<div>Owner/Applicant</div> <div>DCR/PHOENIX HOMES</div>		<div><div><div><div></div><div></div></div><div>PHOENIX HOMES</div></div><div><div>LOT 137</div><div>SITE/GRADING PLAN</div><div>WHITE TAIL RIDGE PH.IV</div></div></div>	
<div>Telephone # 723-9227</div> <div>Plan # 27M- 47</div> <div>Project name: WHITETAIL RIDGE</div> <div>Civic Address: 111 FRANK FISHER CRESCENT</div> <div>House model: SPRINGFIELD 'C'</div>		<div>INDIVIDUAL LOT GRADING REVIEW SUMMARY FOR SITED HOUSE AS COMPARED WITH OVERALL SUBDIVISION PLAN</div> <div>CHECKED/APPROVED BY: T.L.MAK ENG.</div>	
<div>Bldg. Ht. 6.17 m</div> <div>Lot coverage 10.1 %</div> <div>Scale 1:250</div> <div>Sod Area 1992 m<sup>2</sup></div> <div>Asphalt Area 104 m<sup>2</sup></div>		<div>NOTE: THIS PLAN IS NOT A SURVEY PLAN OR SUBDIVISION PLAN WITHIN THE MEANING OF PLANNING ACT.</div> <div>THIS PLAN IS FOR REFERENCE ONLY AND IS PRELIMINARY IN NATURE, ALL DIMENSIONS SHOWN ARE APPROXIMATE. E.O&amp;E.</div>

October 4, 2023 (Revised)

**Re: Proposed Single Family Dwelling, 111 Frank Fisher Crescent, Lot # 137 White Tail Ridge, Almonte,  
Kollaard Associates File # 230020**

With regard to structural issues only, Kollaard Associates has revi

LEFT SIDE ELEVATION M  
WITH SUNROOM

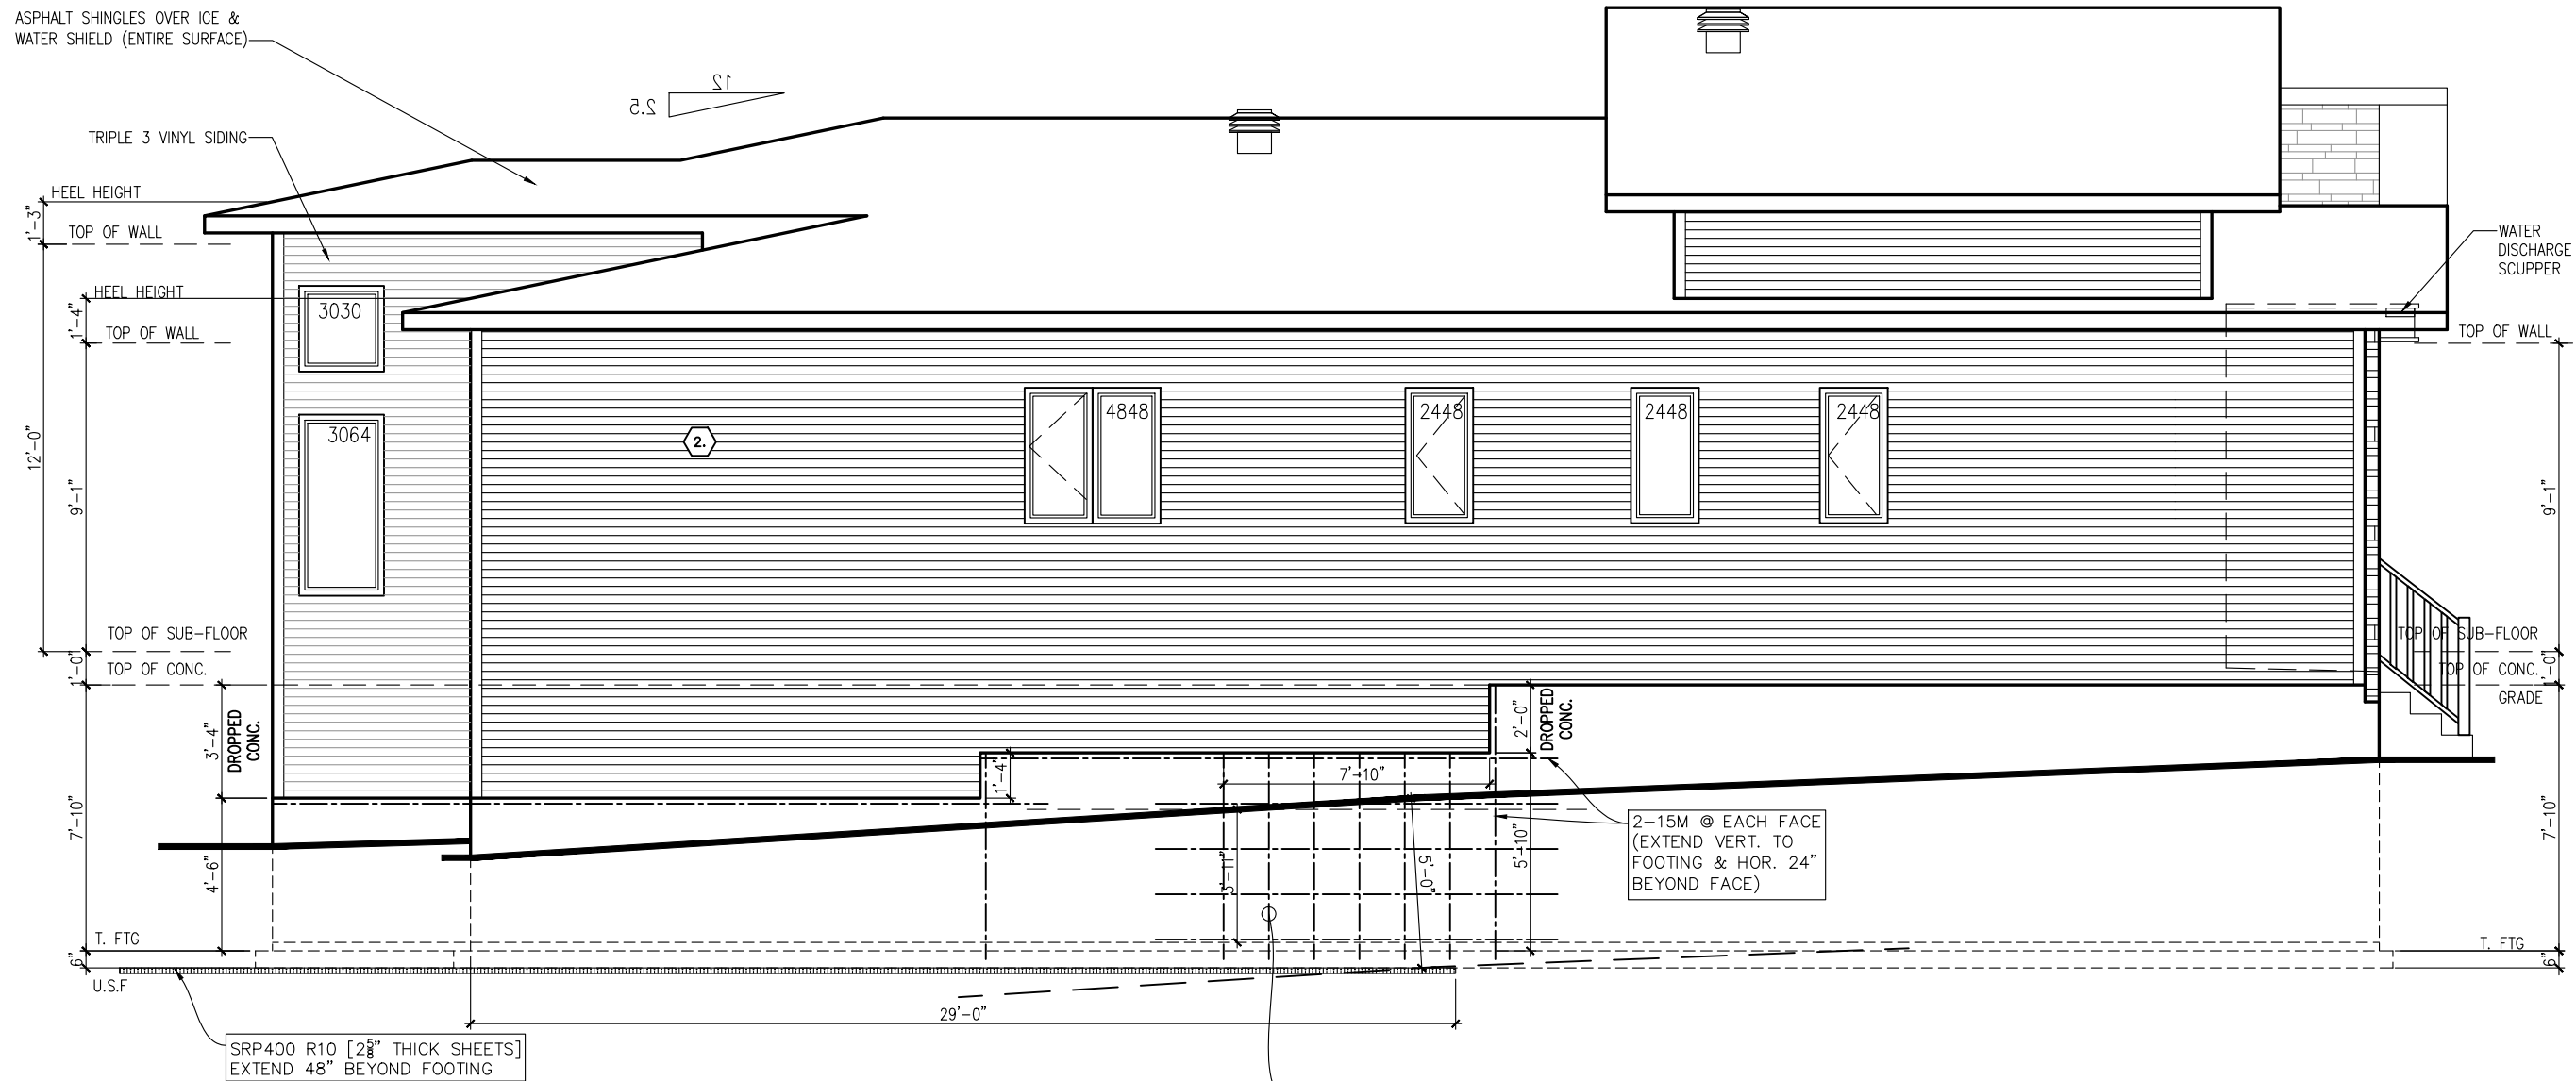
12. Where the grade difference between the basement slab and the exterior finished grade exceeds 3'-11" along the left side, the proposed foundation reinforcement noted on Phoenix Homes Page # 6 is adequate to withstand the lateral earth pressures.

JOB:  
PHOENIX HOMES  
WHITETAIL RIDGE  
WTR4-137  
SPRINGFIELD M  
W/ SUNROOM  
1ST FLOOR 1 OF 1

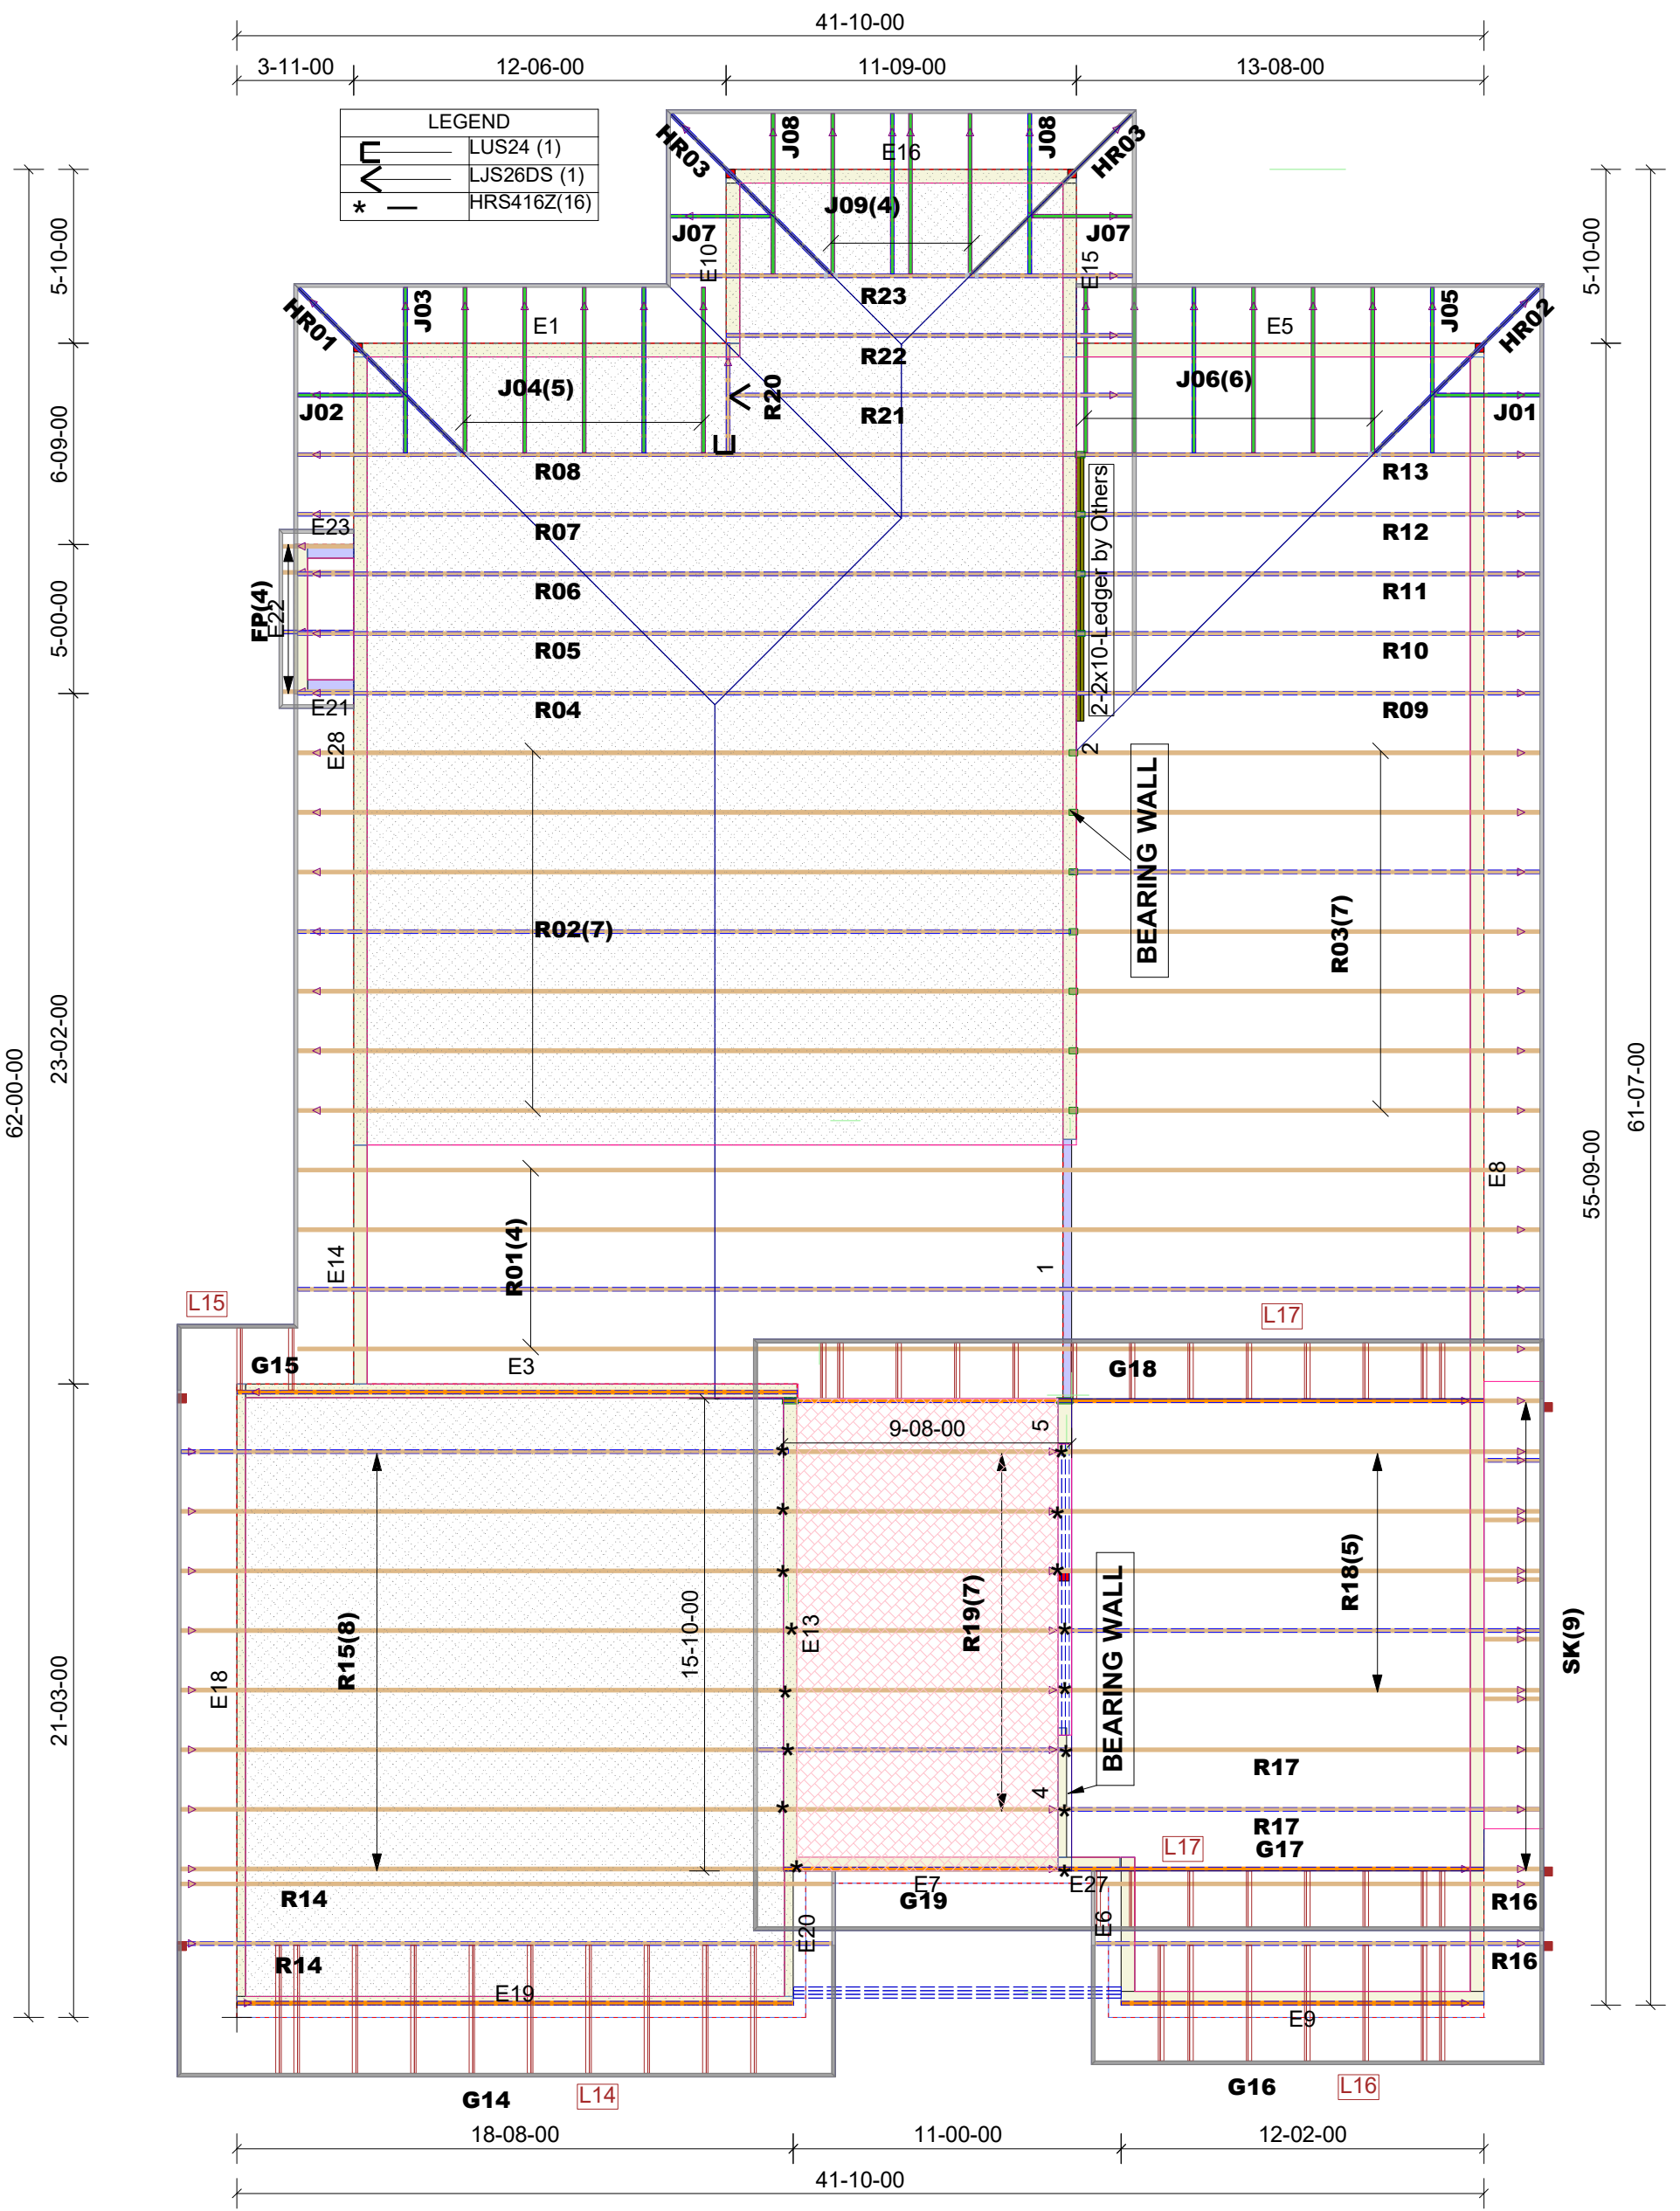
13. The strip footings and proposed interior pad footings shown on Phoenix Homes Page # 2 and noted on Phoenix Homes Page # 1 are adequate.
14. Floor joist design, flush LVL beams/lintels within the floor structure and LVL lintels are by the manufacturer. The posts supporting the flush LVL beams/lintels shown on Phoenix Homes Pages # 2 are adequate.
